# MM11

TECHNICAL  
INFORMATION  
COMPANY CONFIDENTIAL

EP-MM11-TI-A  
COPYRIGHT © 1978  
FICHE 1 OF 1

Title QUALADYNE 1540 SENSE AMPS				Tech Tip MM11 Number 01	
All	Processor Applicability	Author DON ZERESKI	Rev A	Cross Reference	
		Approval CHUCK DEWEY	Date 6/27/72

FIGURE 2

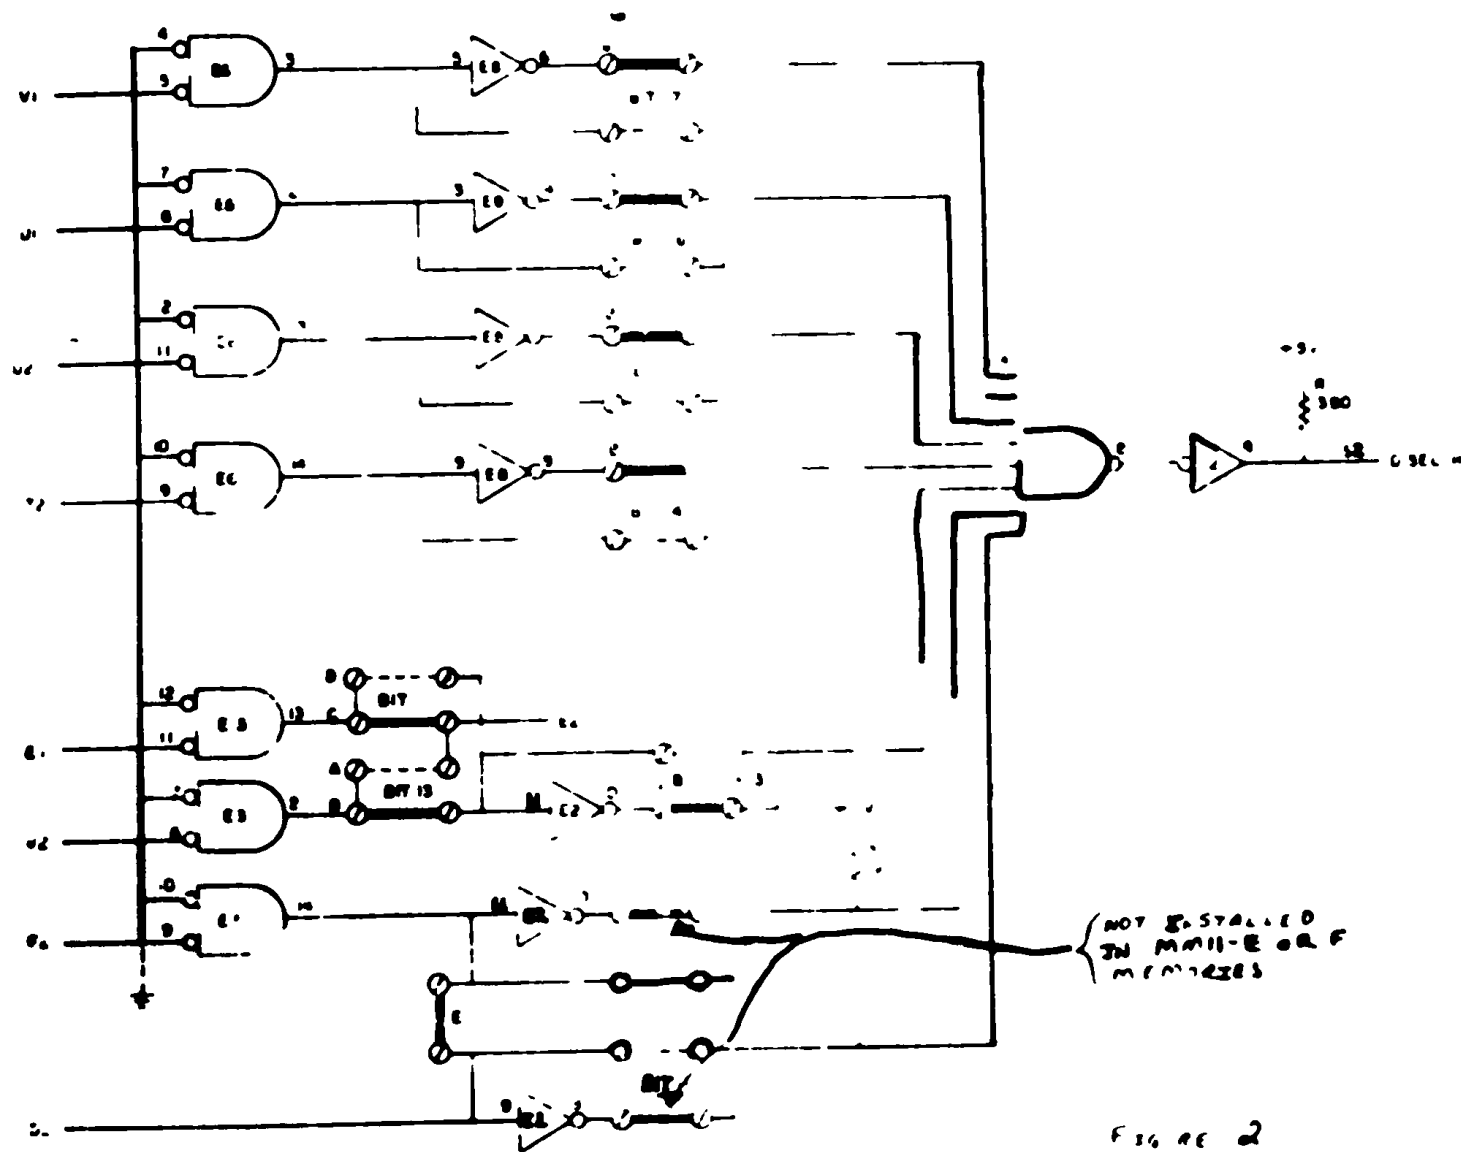
Both the MM11-E and MM11-F memories now utilize M1091 address selector modules. Figure 2 shows the circuit schematic of the M1091 address selection logic. Figure 1 shows a layout of that portion of the physical module where the addressing is accomplished by insertion or removal of jumper wires. Table 1 lists the following:

- d. Bits 17, 16, 15, 14, 13 and 01 Non-Interleaved  
These columns show, by an X, that jumper which should be installed in order to respond to a specific memory bank addressing. The 1, 0, A, B, C and D correspond to the identification shown on the module, figure 1, and figure 2.

- e. Bits 13, and 01 Interleaved - These two bits accomplish the interleaving for MM11-F memories and are to be used in place of their counterparts listed for d, above. When used these cause modification of two 4K Banks so that their addressing has the lower (odd) bank with addresses ending with 0 or 4 and upper (even) bank ending with 2 or 6.

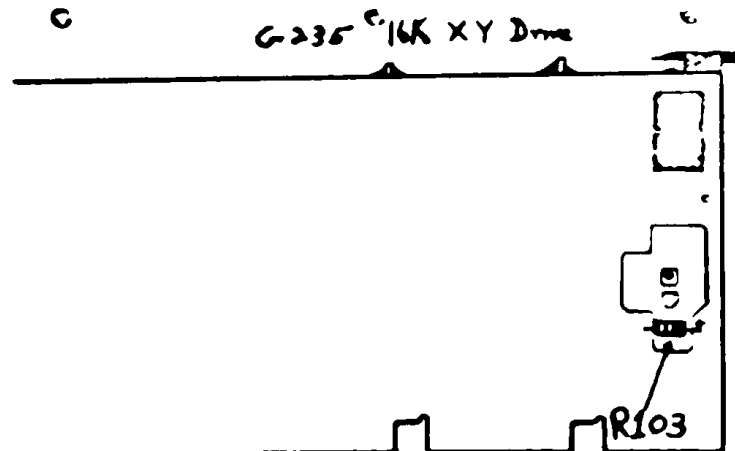
Many reports have been received from the field concerning memories failing high current margins and module set incompatibility (i.e. unable to swap modules). Investigation has shown that the inhibit margins are not properly centered, which could cause marginal operation of the memory under conditions of high drive currents. An EOD (G235-0009) was generated to correct this problem.

Therefore, if a memory exhibits these symptoms, do a visual inspection of the G235 for the EOD. A quick check for the EOD is:

1. Place G235 component side up and fingers toward you.
2. Look at right hand side of module in large etch area (see drawing).
3. If resistor R103 (75Ω 1W) which is across bottom of large etch is not in, EOD has not been installed.

This EOD should be installed before attempting massive module swap or option swap.

ECO# MM11E-00016 D-AD-7006468-0-0

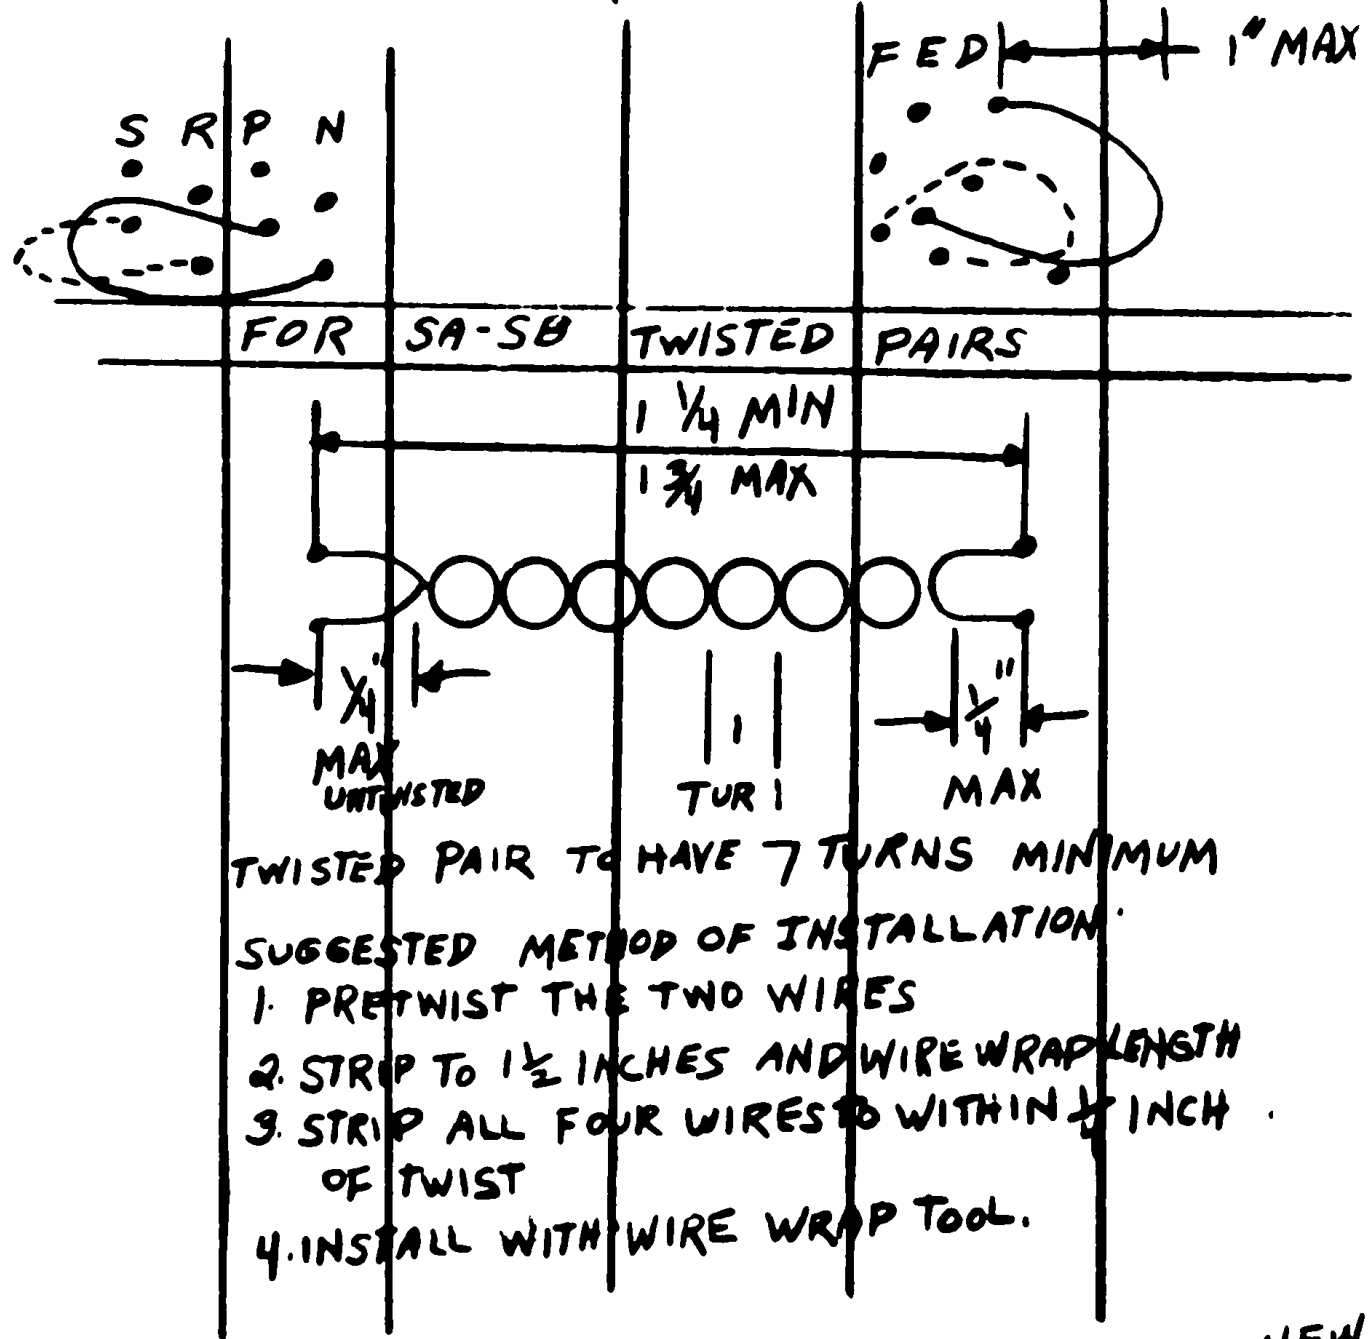
LENGTH SHOULD BE A MAXIMUM OF 2 1/4 INCHES. CHECK DRAWINGS FOR LENGTH AND FOR HOW LOOPS SHOULD BE DRESSED INTO LOGIC.

ECO NO.  
MM11E-00017  
Sheet 2 of 4

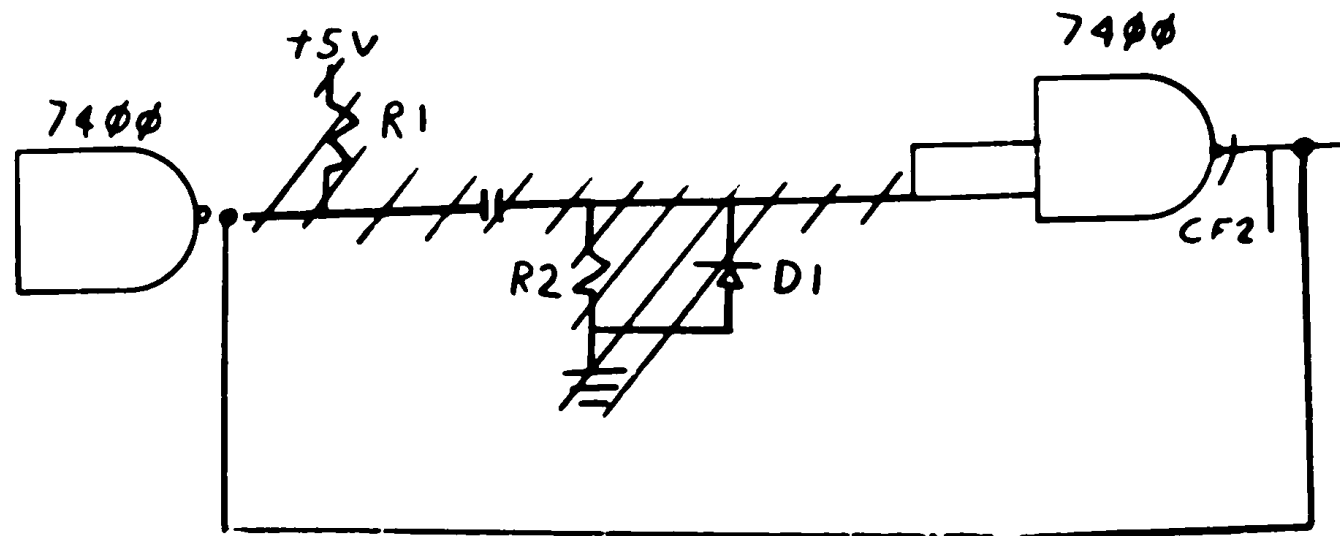
1. CHANGED TEST PROCEDURE TO IMPROVE MEMORY PERFORMANCE. 2. CORRECT WIRE LIST ACCORDING TO SUBMITTED ADD/DELETE SHEET. 3. UPDATE BLOCK SCHEMATIC PER ATTACHED MARKED UP PRINT. 4. UPDATE TIMING AND FLOW DIAGRAM AS INDICATED. 5. REMOVE WRITING FROM MARGIN.		
<b>APPROVAL</b>		
DESIGN ENGINEER <u>P. DURANT</u>	ENG MGR _____	FIELD SERVICE (ADVISORY) <u>J. BUZYNSKI</u>
PRODUCTION ENGINEER <u>S. CALL</u>	CHIEF ENGINEER _____

ITEM	DOCUMENT/OR PART NUMBER	OLD REV	NEW REV	(PART NAME) DESCRIPTION OF CHANGE	DISP CODE
1	A-ML-MM11-E	P	R	(MASTER LIST) UPDATE REVISION LEVEL ON THE FOLLOWING DRAWINGS: D-BS-MM11-E-05 FROM A TO B K-WL-MM11-E-07 FROM C TO D D-TD-MM11-E-08 FROM B TO C A-SP-MM11-E-11 FROM O TO A	06
2	D-BS-MM11-E-05	A	B	(BLOCK SCHEMATIC) SEE MARKED PRINT THIS ECO.	06
3	K-WL-MM11-E-07	C	D	(WIRE LIST) SEE ADD/DELETE SHEET THIS ECO.	06
4	D-TD-MM11-E-08	B	C	(TIMING DIAGRAM) DELETE CHECK RACE COND. IN MARGIN. INCREASE TIME AND FLOW IN DISZ BEFORE 650NS. INCREASE TIME AND FLOW IN CINZ BEFORE 350 NS.	06
5	A-SP-MM11-E-11	-	A	(ENGINEERING SPECIFICATION) DELETE FROM PARA. 11.0 210 NS . ADD 220NS. ADD TO PARA. 13.4- IF THE MARGIN IS GREATER THAN 1.0V SET VXY AT 0.5 BELOW THE FAILING HIGH END POINT (EXAMPLE IF MARGINS ARE 0.4 TO 1.8V, SET AT 1.3V= 1.8-0.5)	06

WIRE LIST NO. K-WL-MM11-E-07

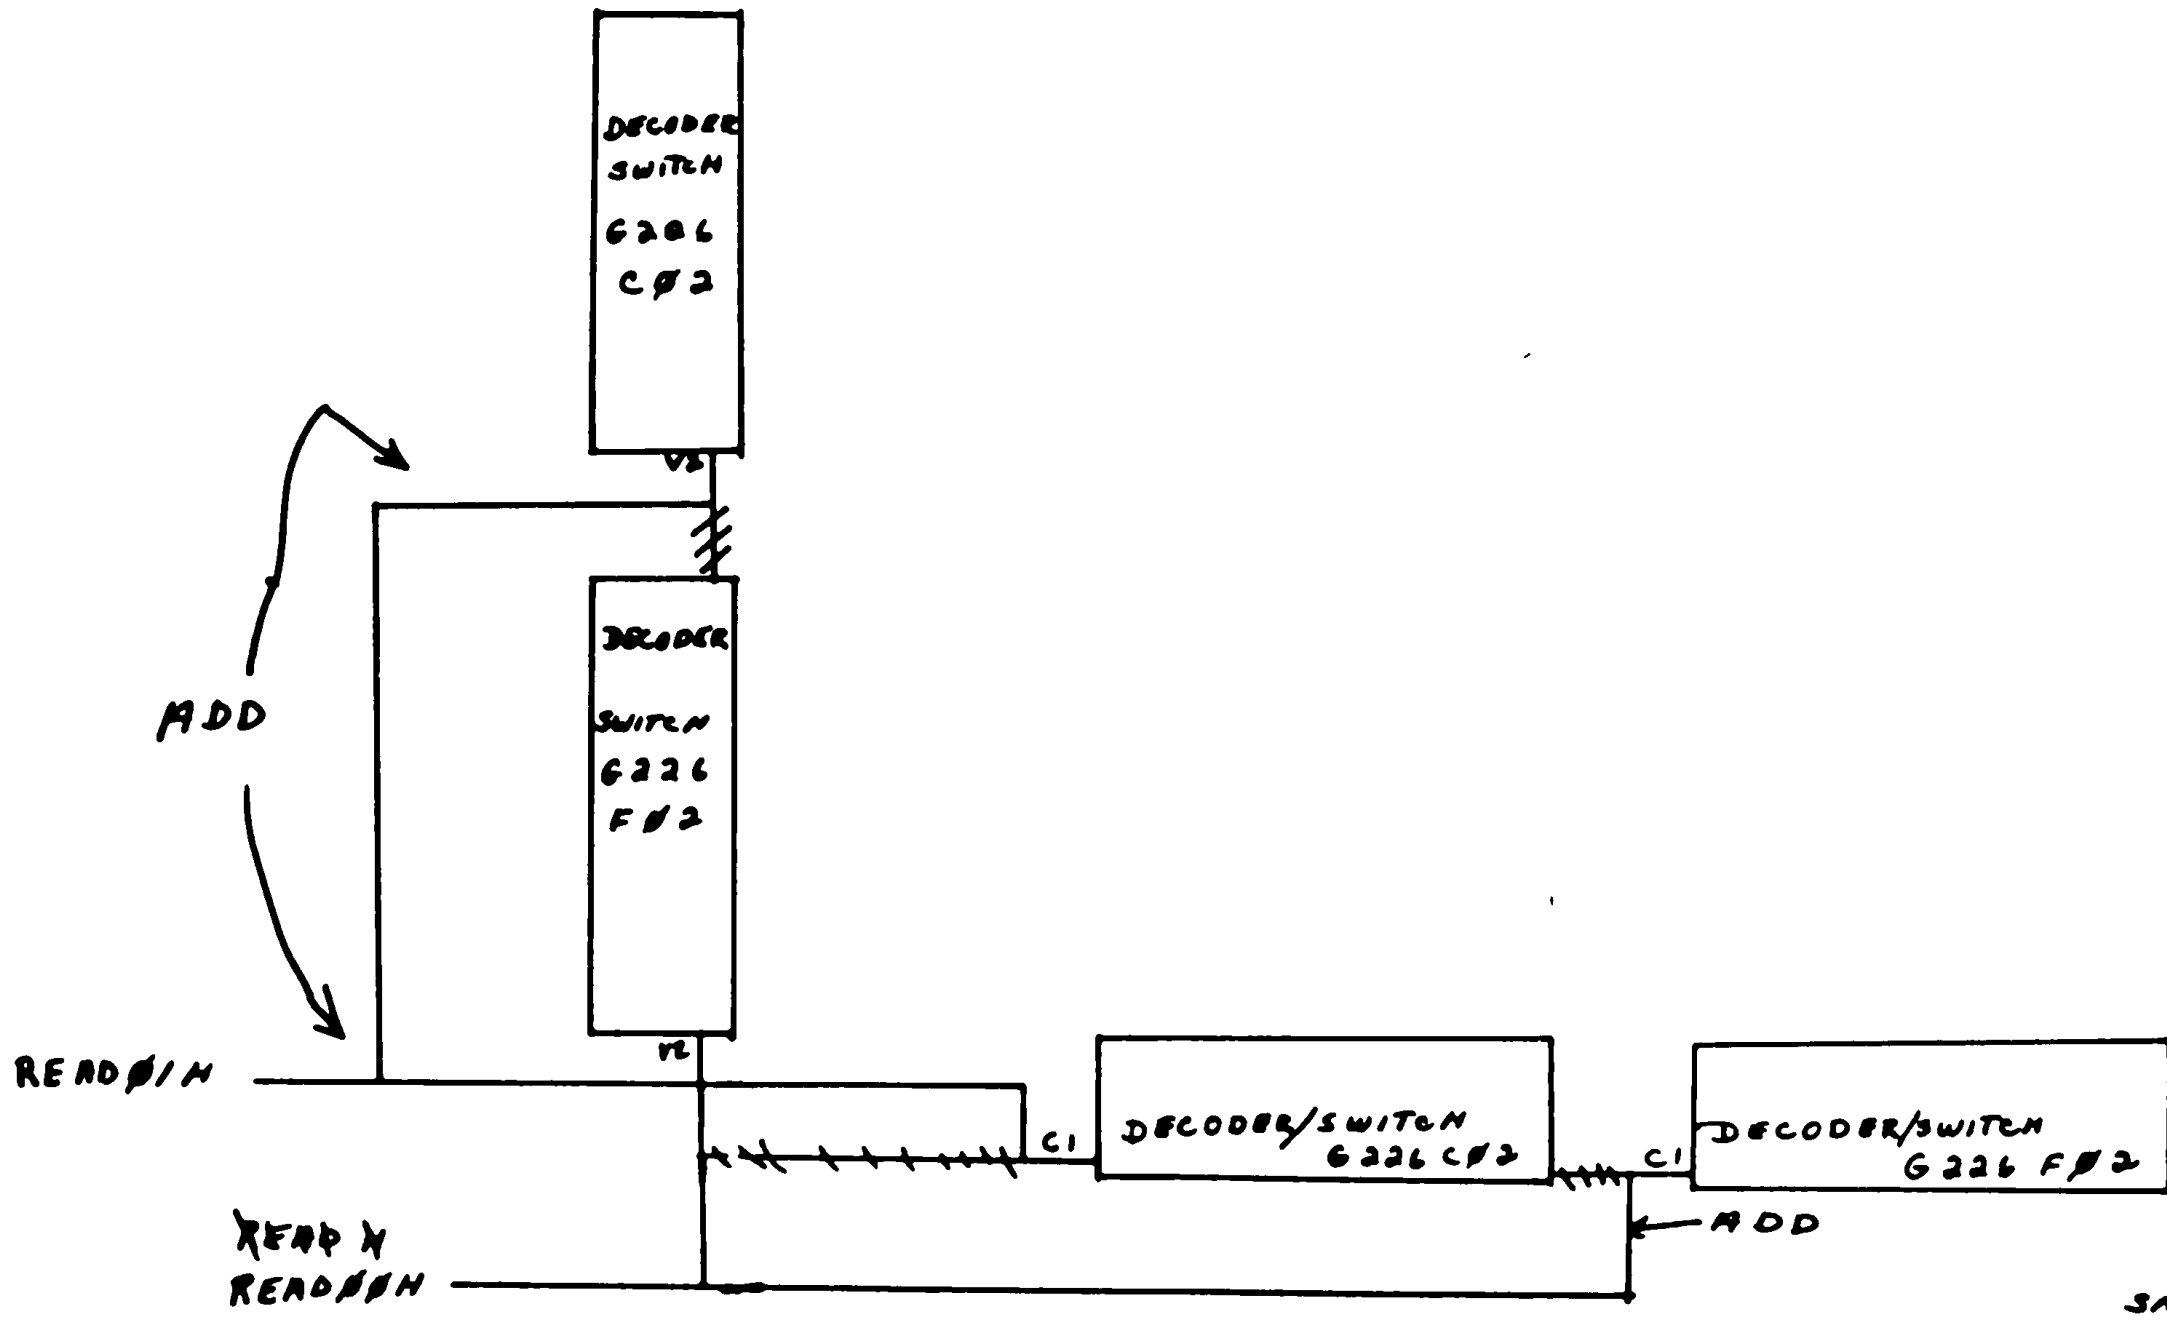
ITEM NO.	DOCUMENT/PART NO.	OLD REV	NEW REV	DESP CODE	DESCRIPTION OF CHANGE	DOCUMENTATION AFFECTED	FIELD SERVICE AFFECTED	TYPE OF CHANGE
1	K-WL-MM11-E-07	D	E	06	Wire List Update	<input type="checkbox"/> MODEL	<input checked="" type="checkbox"/> YES <input type="checkbox"/> NO	<input checked="" type="checkbox"/> ELECTRICAL
2	D-AD-7006468-0-0	D	E	06	Wire Ass'y MM11-E See final release print.	<input type="checkbox"/> DIAGNOSTICS	<input type="checkbox"/> Customer Charge	<input type="checkbox"/> MECHANICAL
3	D-BS-MM11-E-03	A	B	06	Core Memory stack (2 sheets) See final release print.	<input type="checkbox"/> TECH MANUAL	<input checked="" type="checkbox"/> Product Line Change	<input type="checkbox"/> MODULE
4	A-PL-MM11-E	Z	AA	06	UPDATE PRINT PER THIS ECO.	<input type="checkbox"/> TESTER		ORDER PR MODEL
5	C-DI-MM11-E-01	E	F	06	UPDATE PRINT PER THIS ECO	<input type="checkbox"/> TEST PROG		<input type="checkbox"/> YES

SIGNAL NAME	FROM PIN	TO PIN	COMPONENTS	ADD	DEL
READ H	C02V2	D01A1	REMARKS		X
READ 01 H	C01F2	C02C1		X	
STROBE 0 H	C01F1	D02S1			X
STROBE 01 H	C01A1	E02S1			X
TINH 0 H	D02E1	E01S1			X
TINH 1 H	E01H2	F01F1			X
STROBE 0 H	C01F1	D02S1	WHT	X	
GND	C01C2	D02T1	BLK	TWP	X
STROBE 01 H	C01A1	E02S1	WHT	X	
GND	C01C2	E03T1	BLK	TWP	X
T 0 IN H	E01S1	D02E1	WHT	X	
GND	E01C2	D01C2	BLK	TWP	X
T 1 IN H	E01H2	F01E1	WHT	X	
GND	E01C2	F01C2	BLK	TWP	X
